Technical Service Bulletin

Topic	New Continental GT - Front centre console lid (cup holder assembly) fails to latch
Market area	Russische Föderation (5RU),Australia E04 Bentley rest Asia and Australia (6E04),Germany E02 Bentley rest Europe (6E02),Hong Kong 966 Volkswagen Group Hongkong/Macau (NSC) (6966),Japan E03 Bentley Japan (6E03),Russian Federation 935 Volkswagen Group RUS (6935),United Arab Emirates E06 Bentley Middle East and Africa (6E06),United Kingdom E01 Bentley UK (6E01)
Brand	Bentley
Transaction No.	2051937/3
Level	EH
Status	Released for publishing
Release date	Aug 21, 2019

Centre console storage box lid (cup holder assembly) fails to latch

Figure 3

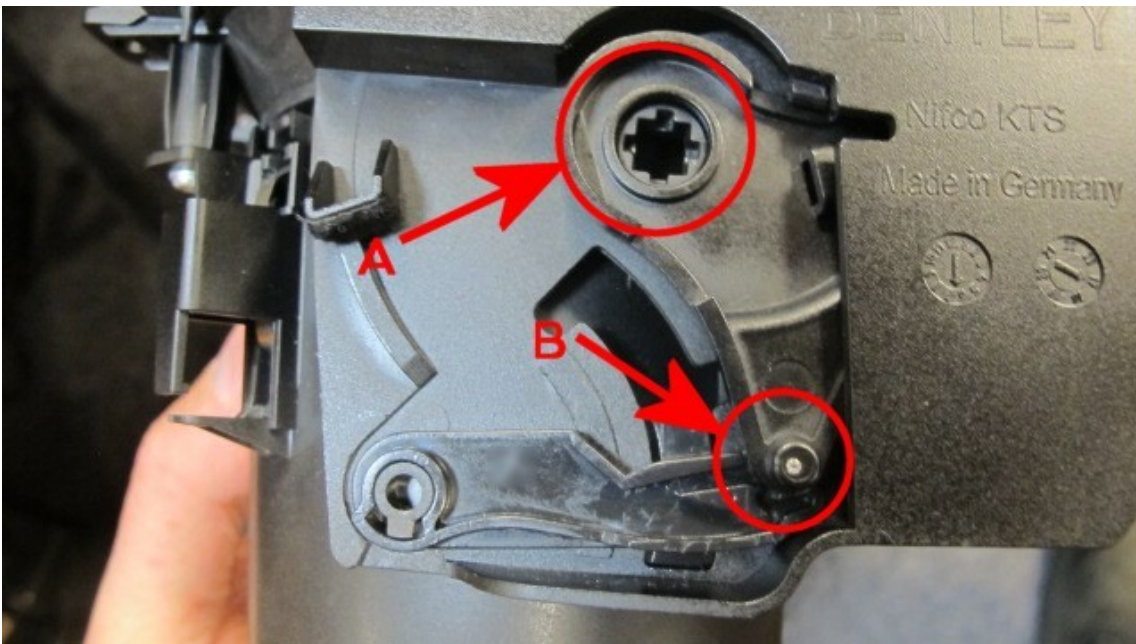
- Referring to Figure 3, Dislodge/manoeuvre the lid drive (Point A) from its upper axis
- Carefully disengage the lid drive locating peg (Point B) out and away from the pawl
